# **FEASIBILITY STUDY FOR THE COLUMBUS McKINNON SITE**

**Columbus McKinnon Corporation  
Tonawanda Facility  
Tonawanda, New York**

**Revised December 1991  
September 1991**

**Re: Columbus McKinnon Inactive  
Hazardous Waste Site #915016  
Submittal of Feasibility Study  
Revision and Response to Comments**

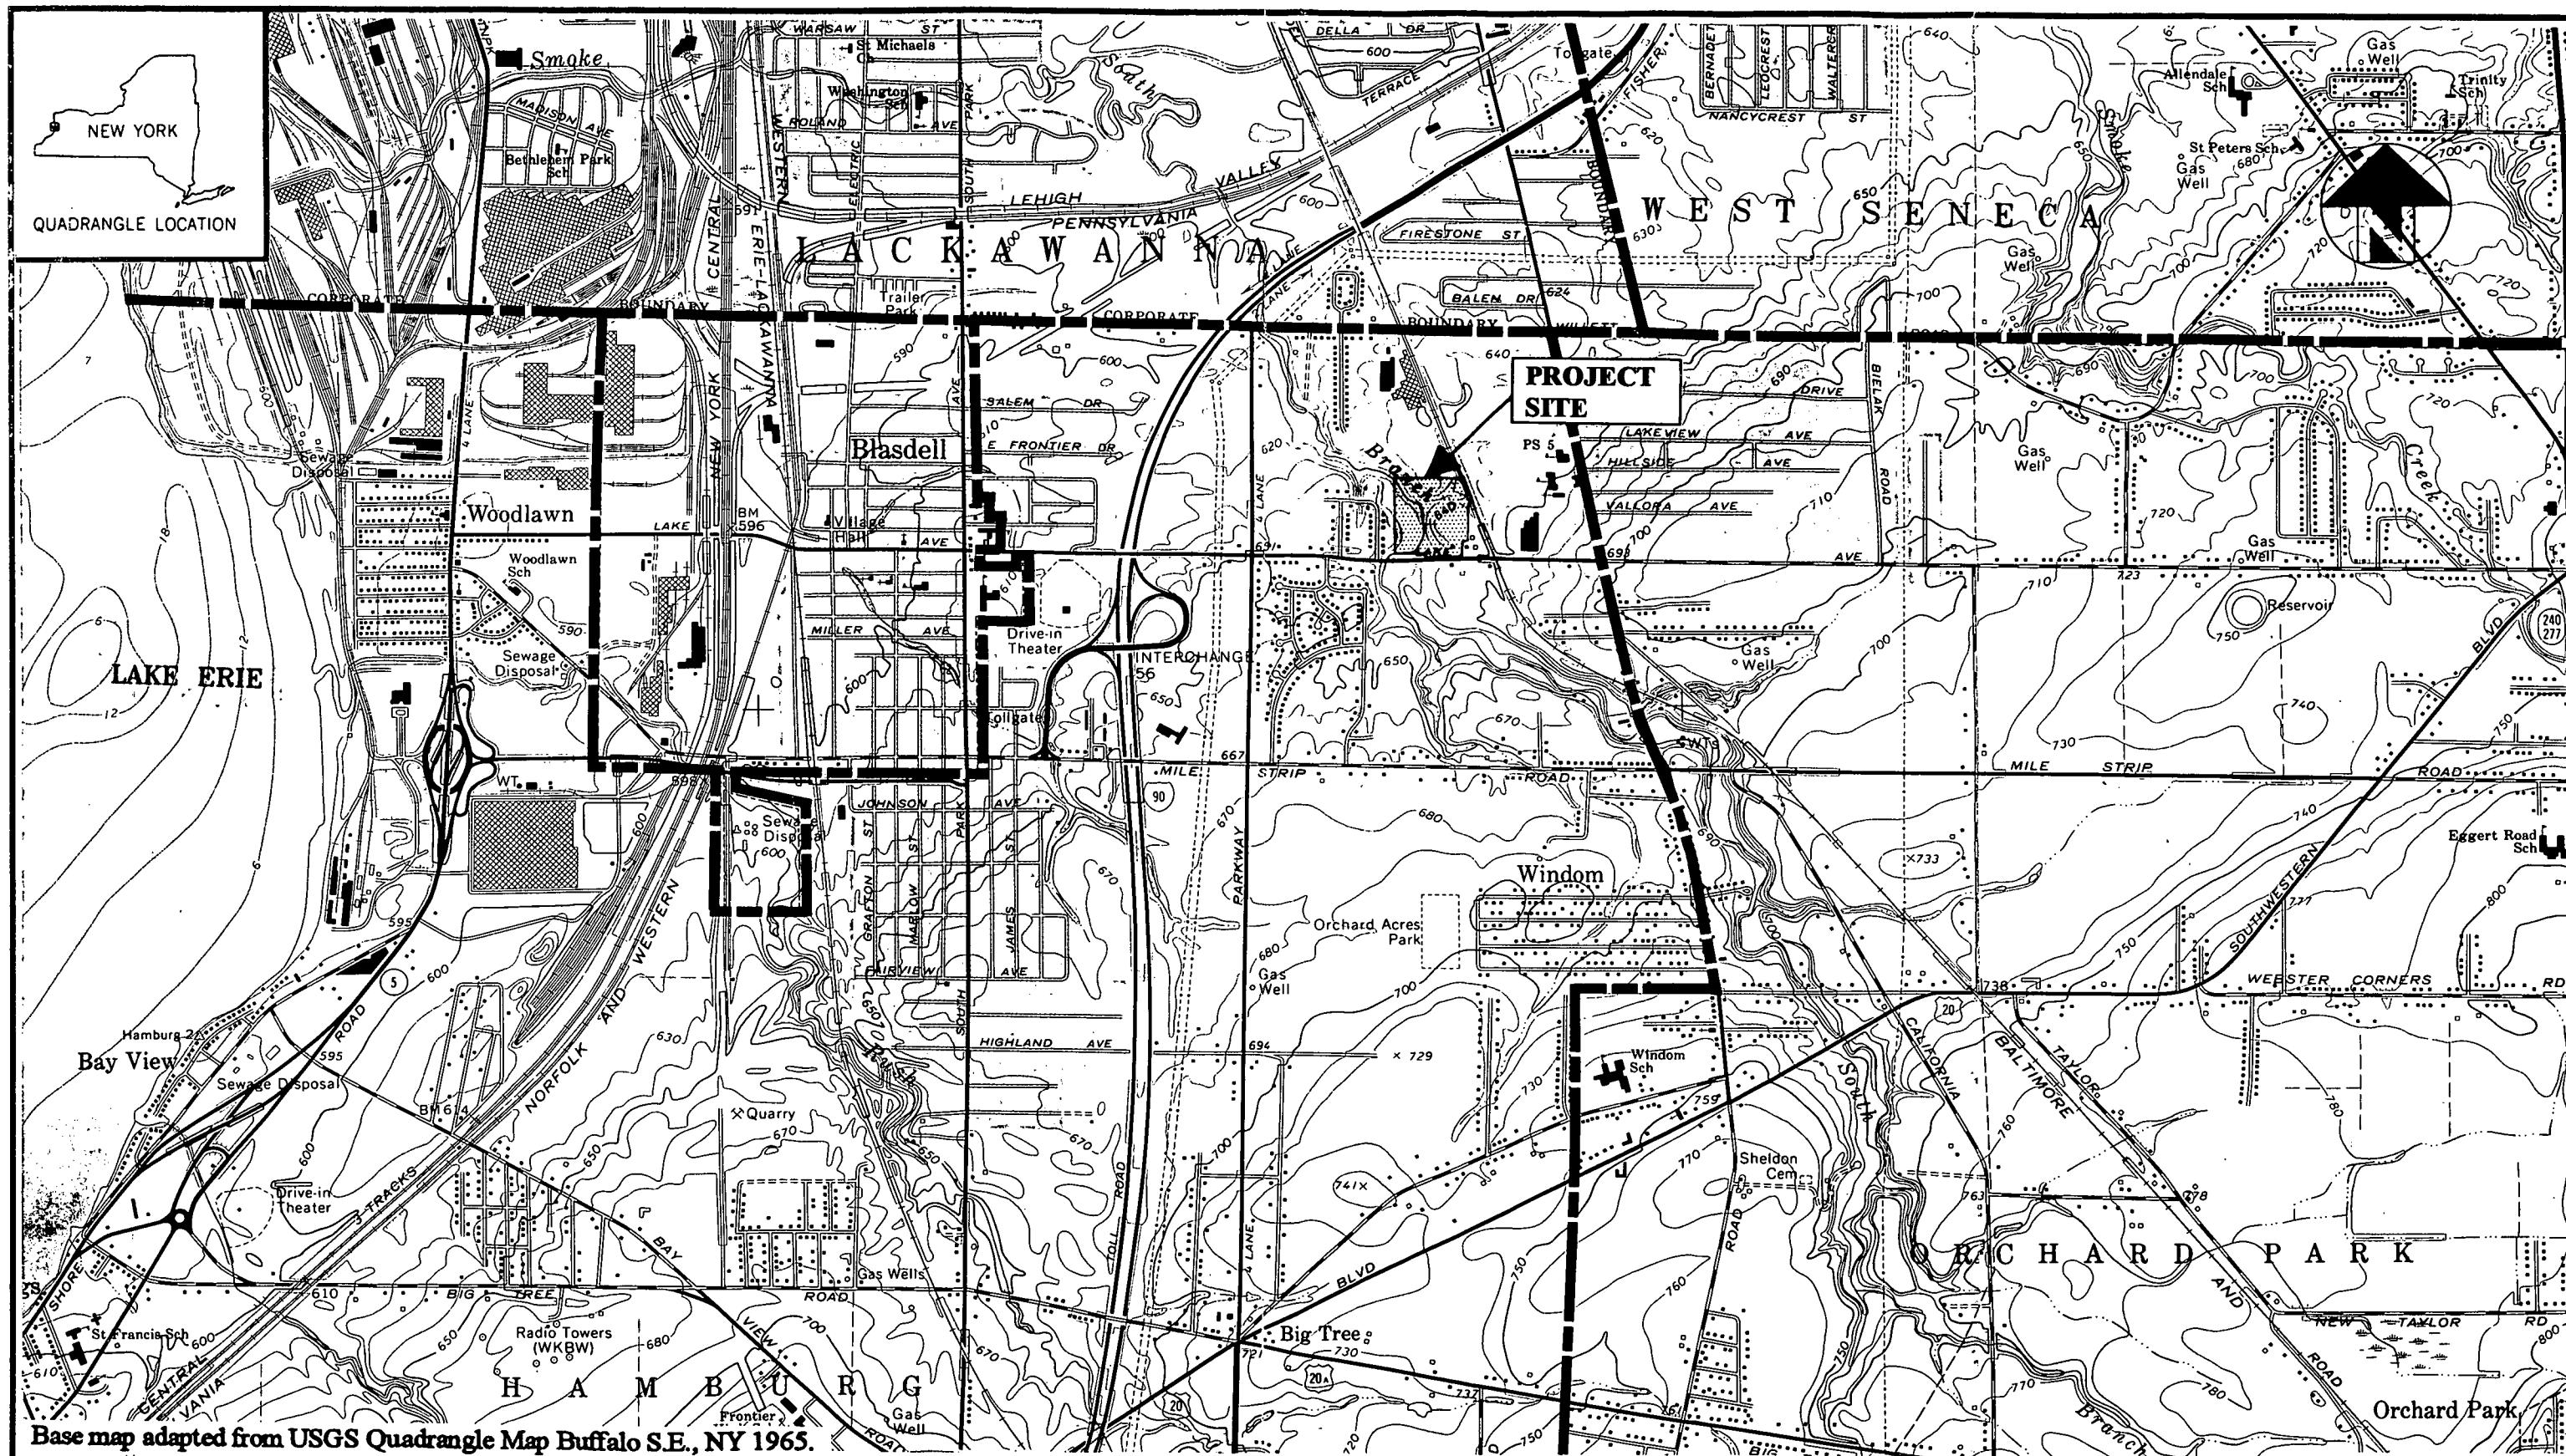
##### Figure 1-2

*The limits of the IRM creek bank stabilization project is shown extending about 25-feet from the base of the creek bank. This is not consistent with Figure 1-2 which shows the riprap ending at the toe of the creek bank. This inconsistency needs clarification.*

This comment has been addressed in Figure 1-2 and Section 1.2.2.3 of the FS report.

The stream survey conducted by Malcolm Pirnie has been more clearly documented in this revised version of the FS report and this has been reflected in Figure 1-2 and Plate No. 1. The routes of contamination migration presented in the FS report are reiterated from those presented in the NYSDEC-approved RI. Consequently, there is no need to revise the FS report to incorporate this comment. The potential contaminant loads introduced by the routes of contaminant migration presented by the NYSDEC are considered insignificant in comparison to the contaminant loads presented in Section 1.2.3 and will not be presented in the FS. Further clarification of the insignificance of these contaminant migration pathways as presented at our October 21, 1991 meeting is presented

As stated previously, the limits of the IRM have been clearly delineated on Figures 1-2 and on Plate No. 1 through survey data compiled on September 12 and 13, 1991. In addition, while the riprap and filter fabric were placed as an "interim measure" its permanence and effectiveness at containment of both creek bank soils and sediments must be considered in an evaluation of remedial alternatives. This is substantiated by the work plan prepared for the existing IRM, approved by the NYSDEC, which states that "the IRM may or may not be incorporated into the final site remediation plan". This is also consistent with the Department's TAGM regarding interim remedial measures dated February 12, 1991, which states that an IRM may become the final remedy.
